IDAP REPORT

Property:	45 Meredith Street Strathfield LOT 8 DP 17827 DA2022.03
Proposal:	Demolition of existing structures and the construction of a two (2) storey dwelling house with a basement level, in-ground swimming pool and associated landscaping works.
Applicant:	PLATFORM 5 DESIGN PTY LTD
Owner:	HG & T Badran
Date of lodgement:	24 January 2022
Notification period:	31 January 2022 – 14 February 2022
Submissions received:	Nil
Assessment officer:	L Gibson
Estimated cost of works:	\$1,439,885.00
Zoning:	R2 – Low Density Residential - SLEP 2012
Heritage:	No
Flood affected:	No
Is a Clause 4.6 Variation Proposed:	No
RECOMMENDATION OF OFFICER:	APPROVAL

Figure 5: Proposed Basement Floor Plan.

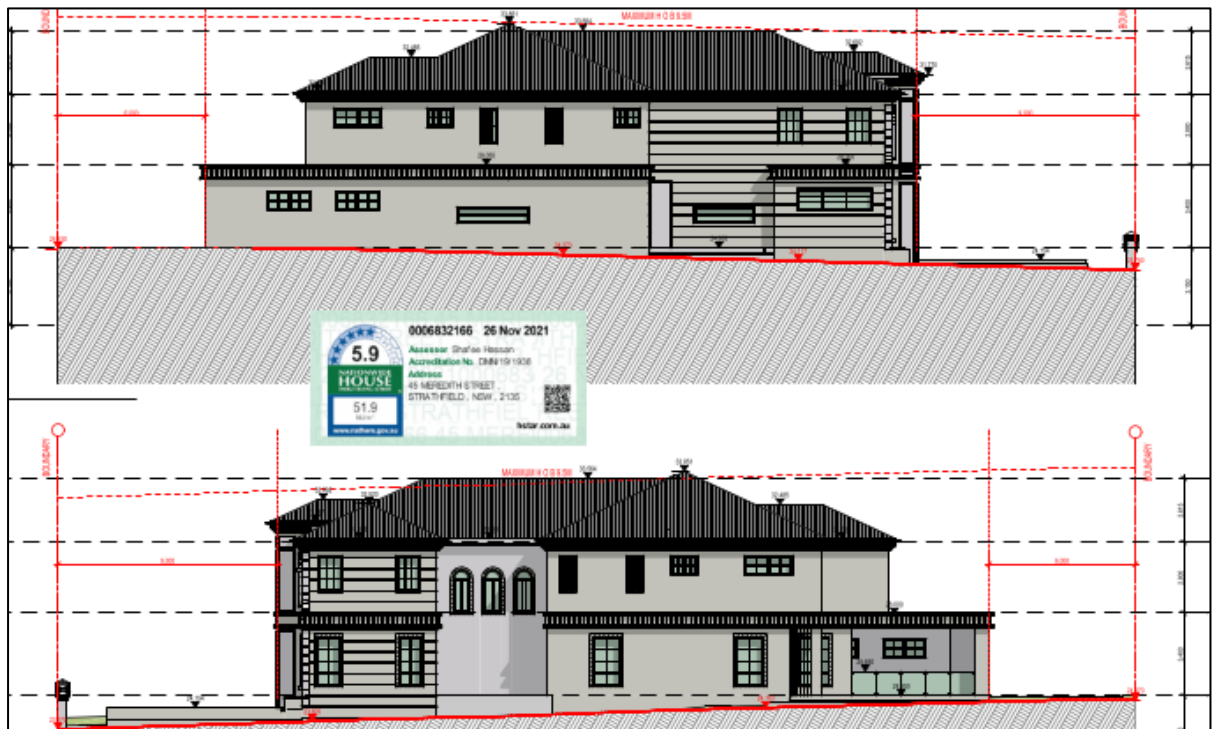
6 April 2022	An amended basement plan was submitted to Council via the online Planning Portal demonstrating a more confined basement footprint and thus achieving a compliant FSR.
--------------	---

The proposal involves significant excavation works for the provision of a basement, driveway ramps and ancillary works. During the assessment process, further revisions have been prepared with regard to the basement plan so to achieve a more reduced footprint. Whilst a portion of the basement (directly beneath the northern winter garden) extends beyond the ground floor above, this is considered acceptable in order to accommodate suitable basement access to the site.

Figure 12: Streetscape Elevation Plan

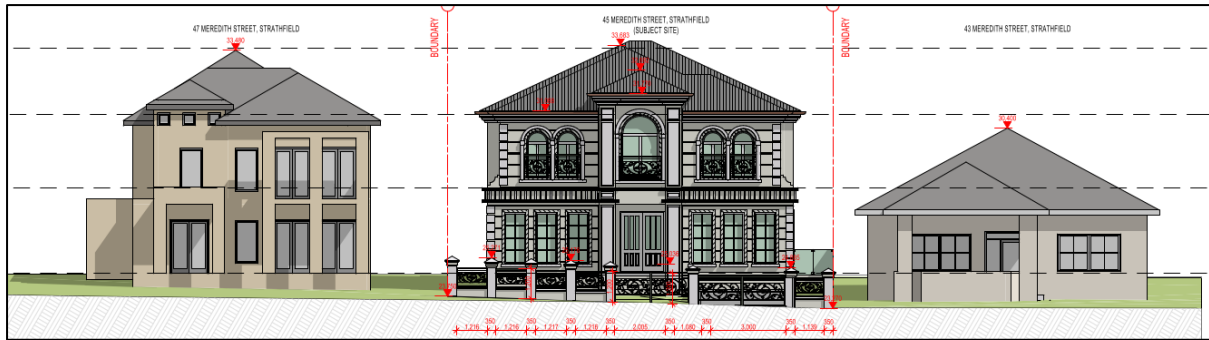
The proposed dwelling provides a French provincial-style dwelling with pitched slate roof, grooved render walls and large vertically-oriented windows with arches across the first floor. The proposed dwelling complies with the prescribed building height, floor space and setback requirements demonstrating that the bulk and scale of the development is appropriate for the site. The proposal is well articulated and will be constructed with high-quality material finishes so that it positively contributes to the presentation of the street.

Figure 13: Landscape Plan

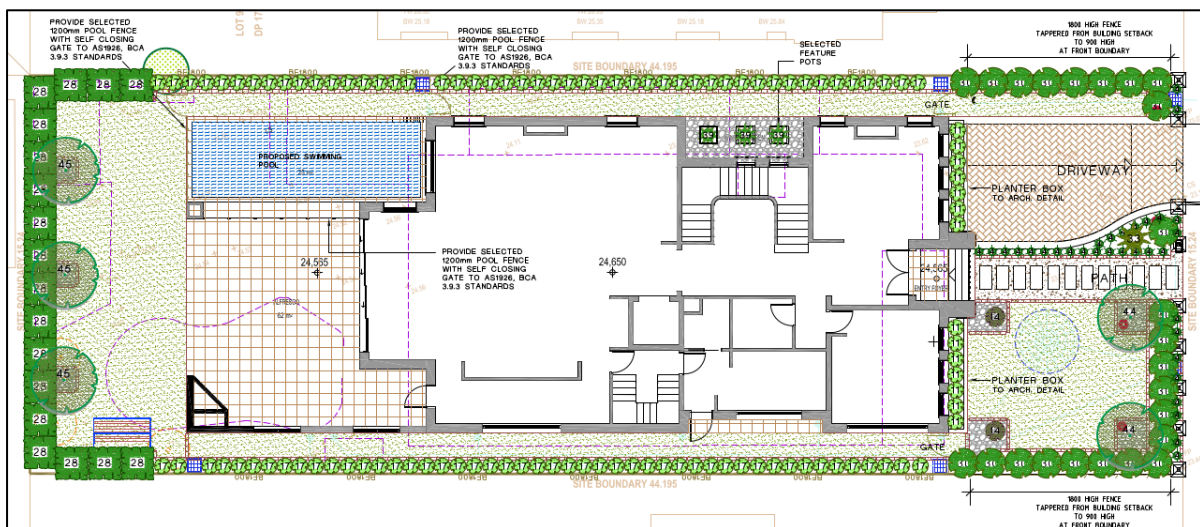
Based on the submitted landscape plan, the proposal results in 40.6% (273.2m²) deep soil zone which presents a 5.14m² shortfall from the minimum 41.5% (278.34m²) required by Part A of the SCDP 2005. The landscape plan proposes a driveway that increases in width from 3m at the property boundary to 4.5m at the front building line. As the proposal provides a basement, the entrance is only required to be constructed to a width of 3.5m. The development therefore provides scope to replace this excessive paved driveway area with deep soil zone in the front setback of the site. Accordingly, a condition of consent is recommended requiring the driveway to not exceed 3.5m in width at any point in the front setback and that all remaining areas be provided with deep soil zone. This should achieve an additional 6.7m² deep soil zone for the site and thus achieve compliance with the minimum deep soil zone requirements for the site.

Figure 15: Rear shadow analysis (47 Meredith Street pictured right)

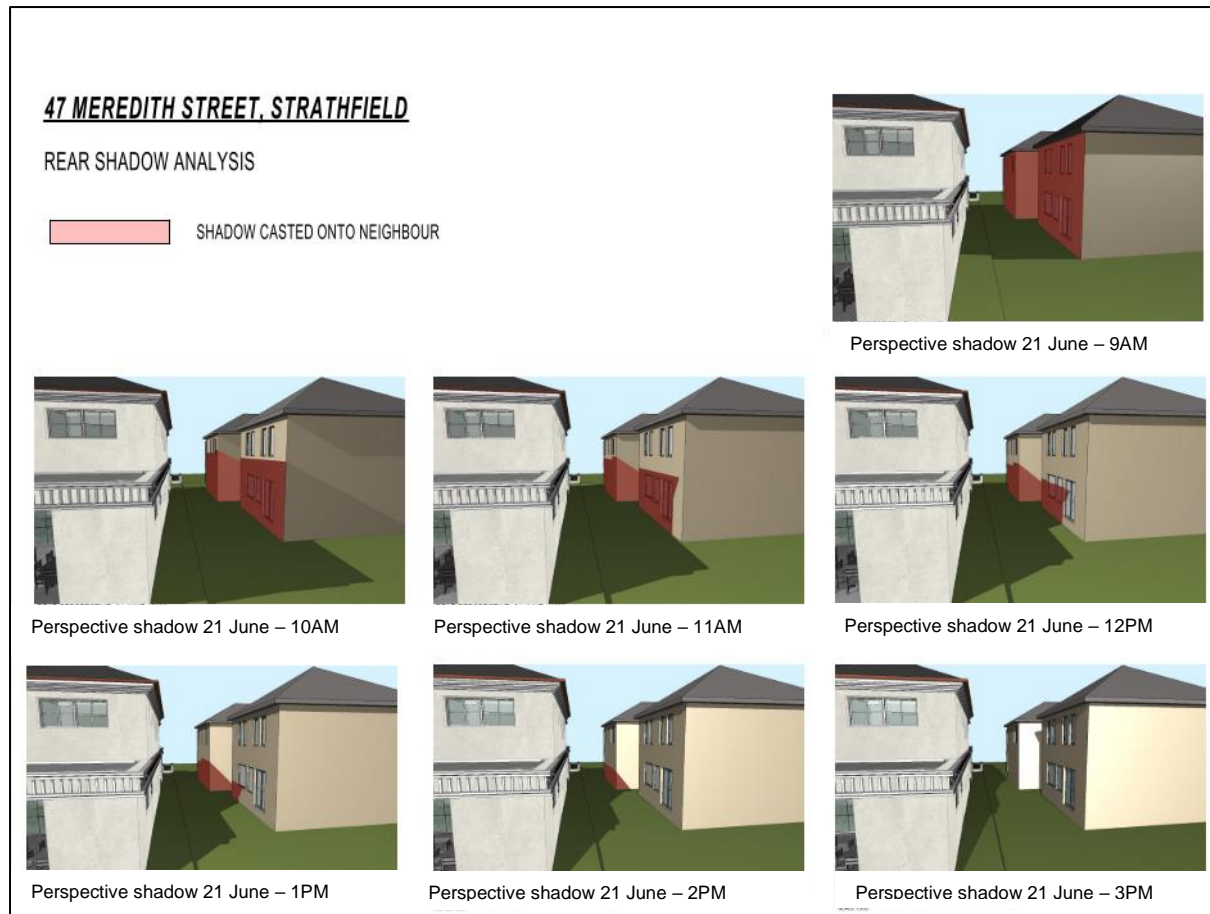
The site is provided with an east-west orientation resulting in an unavoidable degree of overshadowing to the southern adjoining property at 47 Mackenzie Street. The application was accompanied by a series of shadow on elevation diagrams to demonstrate the impact of overshadowing to the southern adjoining dwelling through the day (refer to Figure 14 & 15 below). At 9am, the proposal results in its greatest overshadowing impact on the southern adjoining dwelling whereby all northern-oriented windows are cast in shadow. By 10am, the shadow moves so to enable all first floor windows to receive direct solar access. By 12pm, all windows to 47 Meredith Street receive some, if not direct, solar access through the day.

47 Meredith Street is a corner site which ensures that the dwelling will continue to receive some solar access through the day notwithstanding the proposal. Furthermore, the shadow moves considerably through the day to ensure that both the front and rear yard of 47 Meredith Street will receive a minimum 3 hours direct solar access through the day.
